NONCONFORMANCE REPORT

1 PROJECT NO. *8031*

6 DRAWING/PART NO. *C198 REV 7*

7 ITEM DESCRIPTION *BEAM 184A*

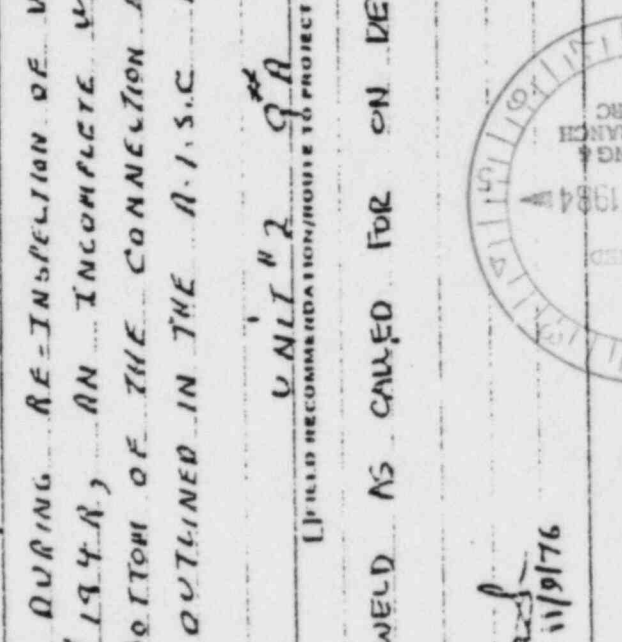
*1* *UNIT # 2 GA 1 HOLE TAG*

*4* *COMPLETE THE WELD AS CALLED FOR ON DESIGN DRAWING.*

*5* *REWORK COMPLETED AS PER BLOCK 20*
